**Present Fire Board of Appeals Board Members (6):**

**3. Appeal**

\*\*\*\*\* (STANDARD COMMENT) This project is: PURVIS RESIDENCE - 400 DAHLIA ST - NEW WUIO HOME HARDENED STRUCTURE REQUIRED

# PURVIS RESIDENCE

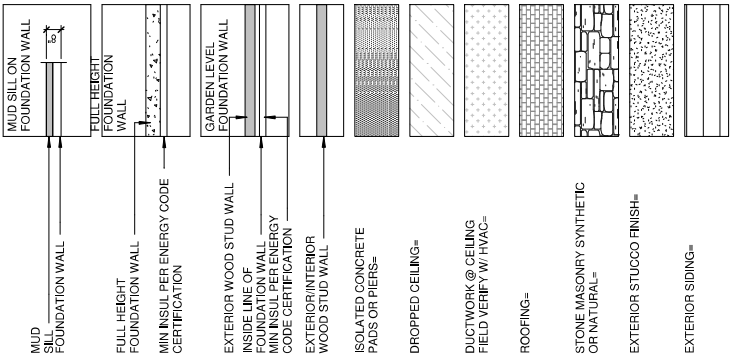
APPROVED  
11/22/2023 9:04:30 AM  
Colorado Springs Fire Department

FIRE ALARM IS IN LIEU OF MEETING REQUIRED FIRE FLOW, CSPD

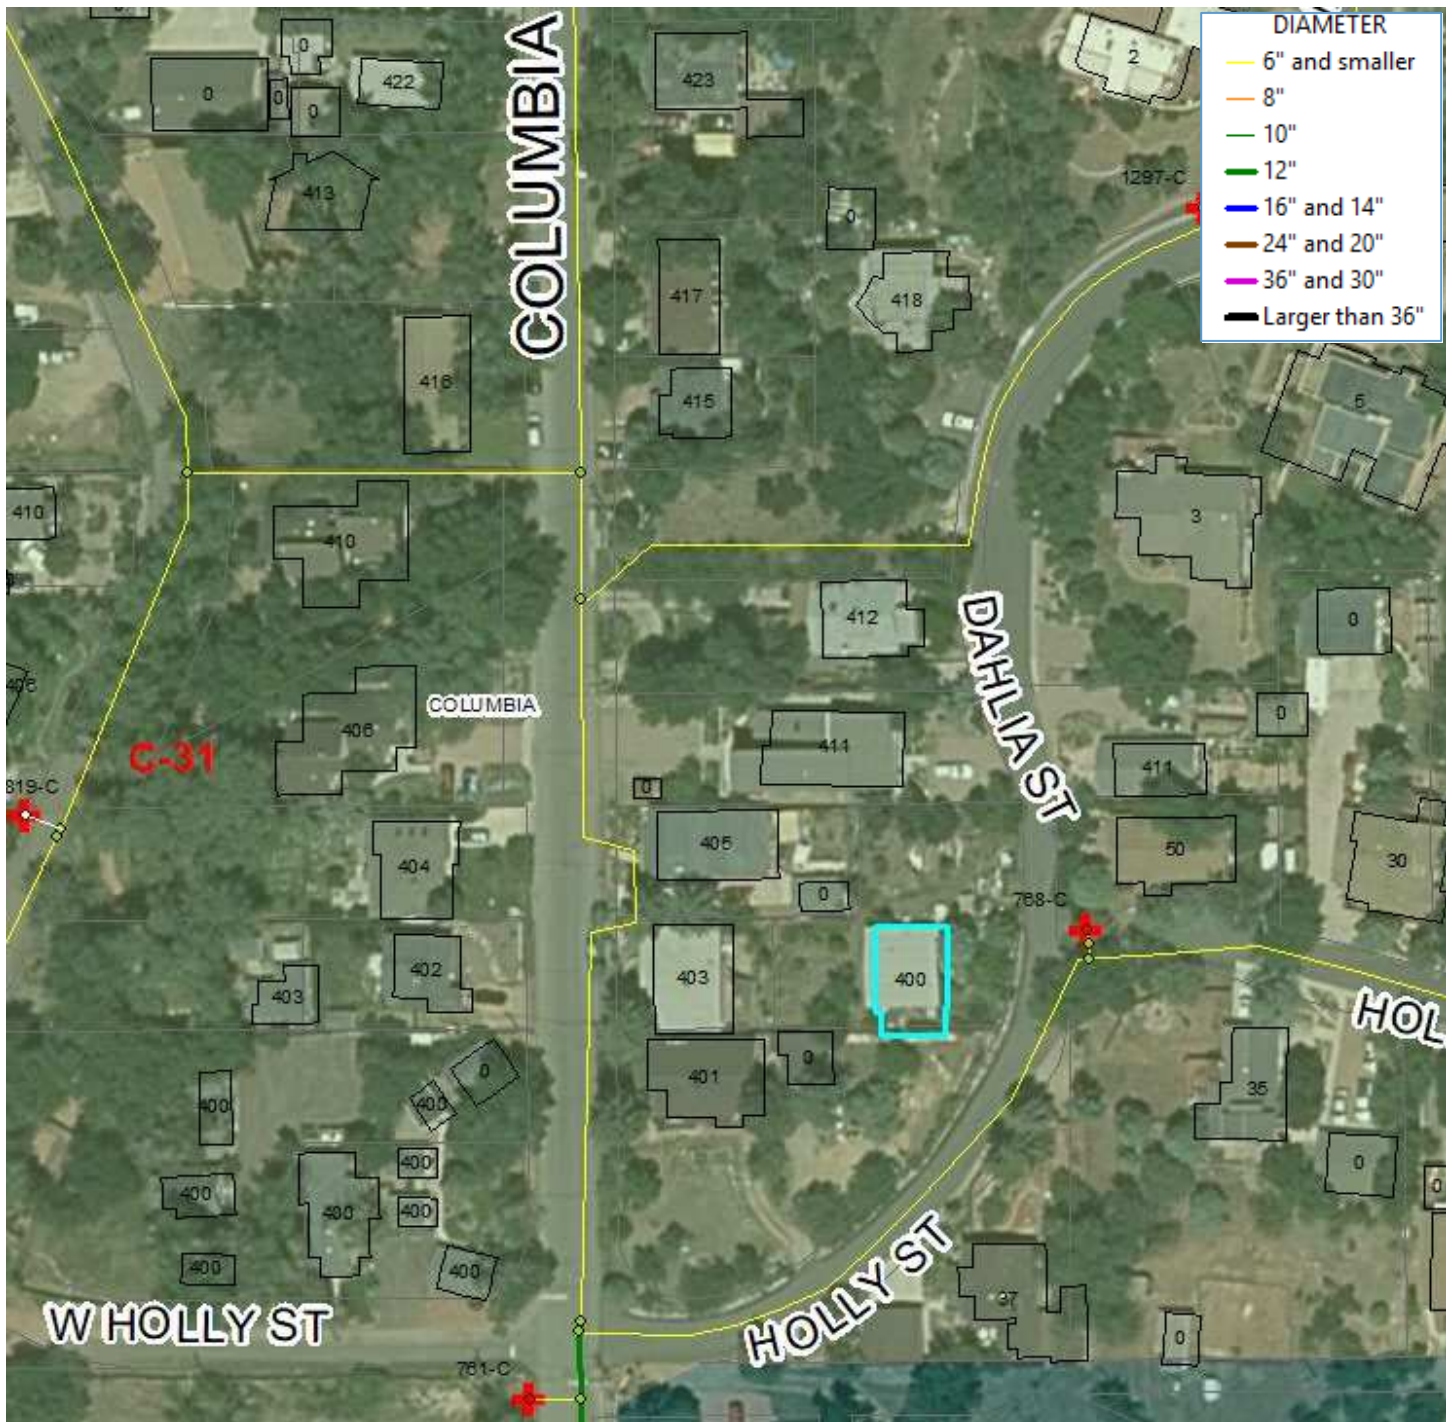
*Comments:*

Flows were less than the minimum allowable flow of 1500 gpm. Colorado Springs Fire Department will determine further actions upon review.
